Q. UNR158

Annex 10. Test methods for **detection** systems

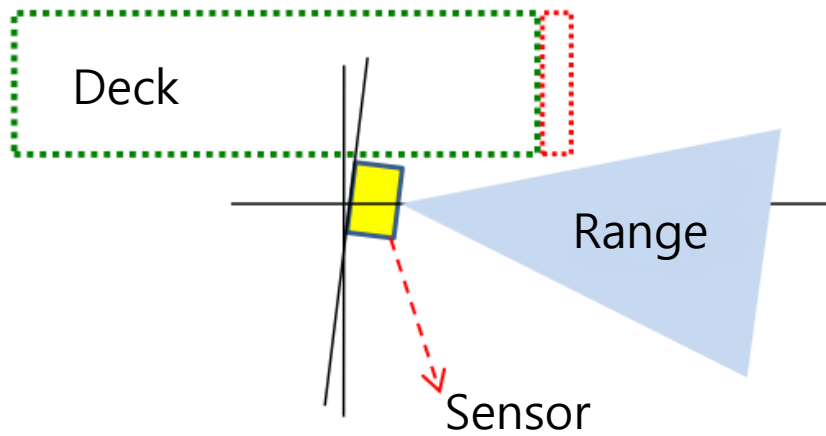
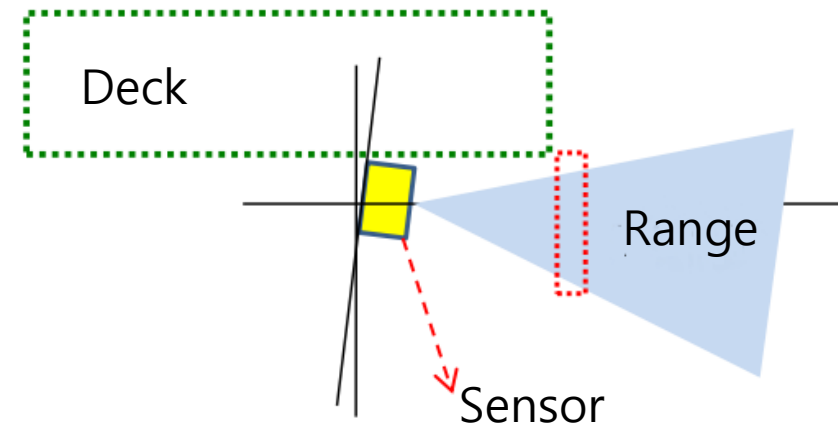
In the Test conditions of Annex 10, there is **no specification** about Rear hatch and trunk lids.

Problem

It may affect operation of sensors

- Difference between Annex 9 (vision) and Annex 10 (detection)
- The test in Annex 10 may be conducted under an abnormal condition,
 - ✓ Such as, a tail gate is open

- Why those are different?
- If needed to be amended, how to amend?
 - ✓ Such as, copy the test condition in Annex 9 and paste it in Annex 10
